Project Name: Clinton Softball Concessions Building
WBA Project Number: 26-010

ADDENDUM NO. 03

1
E-100 LIGHTING PLAN
Scale: 1/4" = 1'-0"

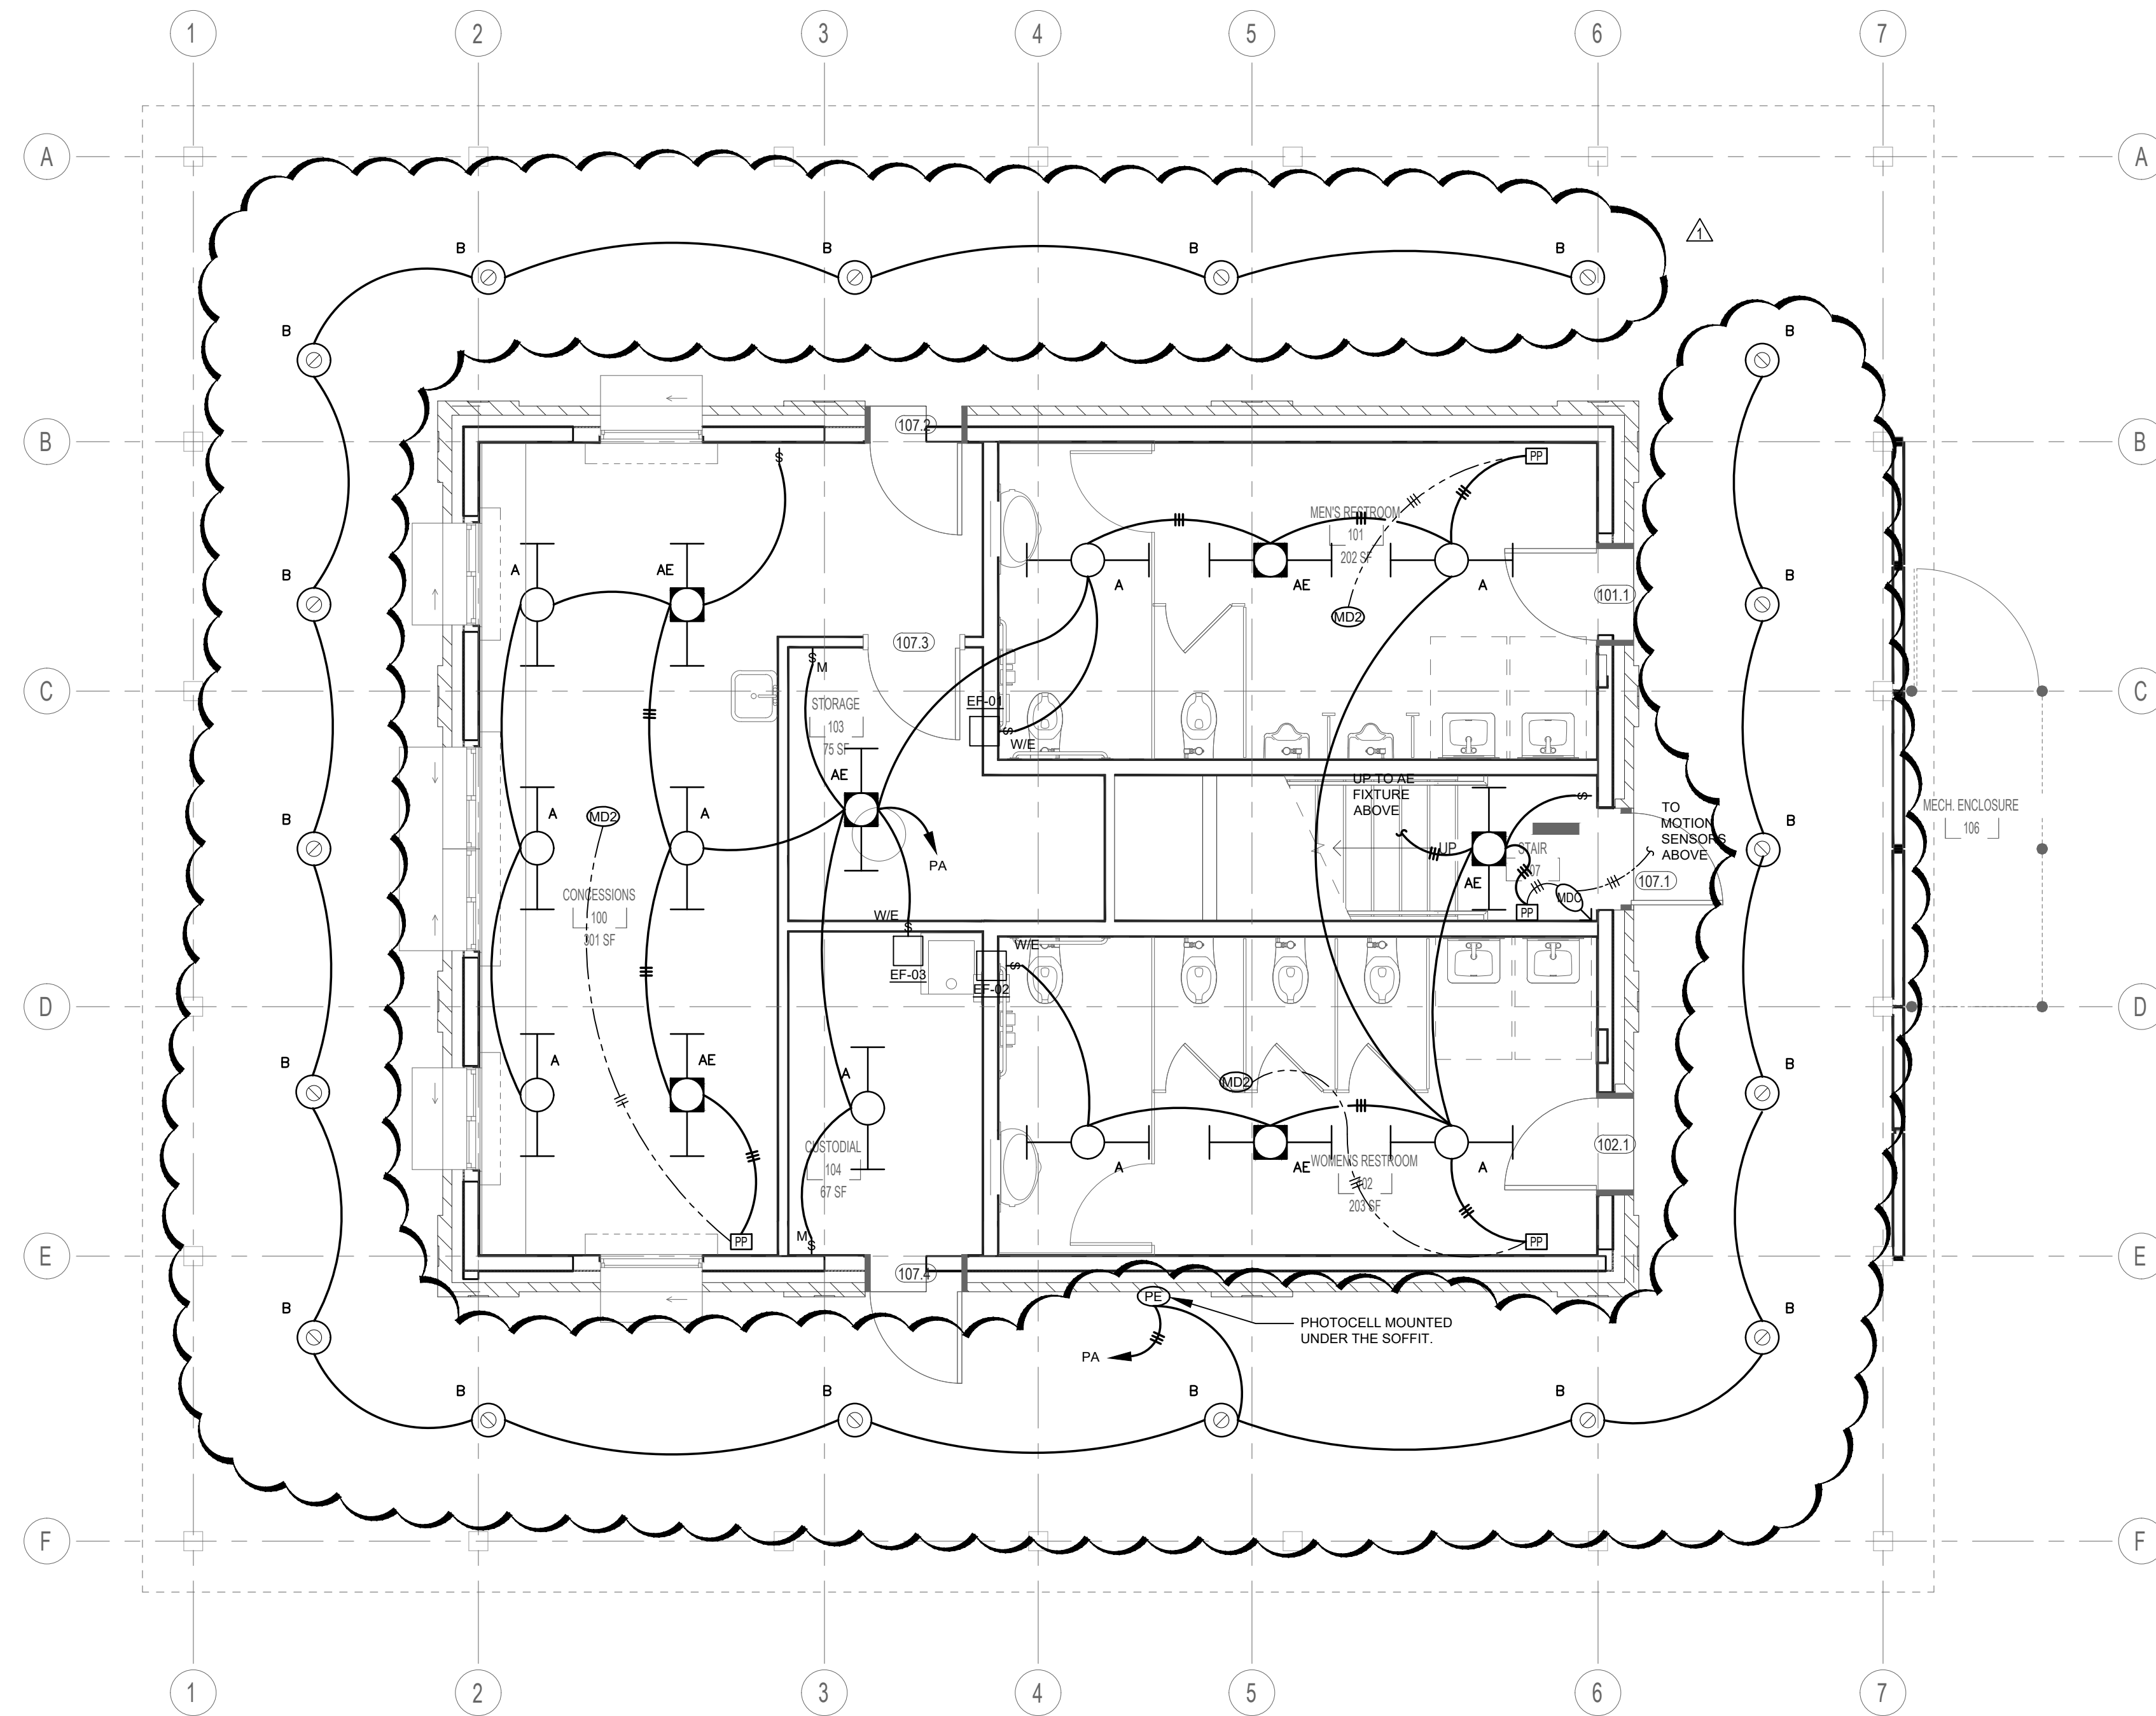
- ITEM NO. 12 Delete and replace A301 in its entirety. Asphalt Shingle Roof Assembly has been updated.
- ITEM NO. 13 Delete and replace A401 in its entirety. Detail notes have been revised.
- ITEM NO. 14 Delete and replace E000 in its entirety. Canopy lighting revised.
- ITEM NO. 15 Delete and replace E100 in its entirety. Canopy lighting revised.
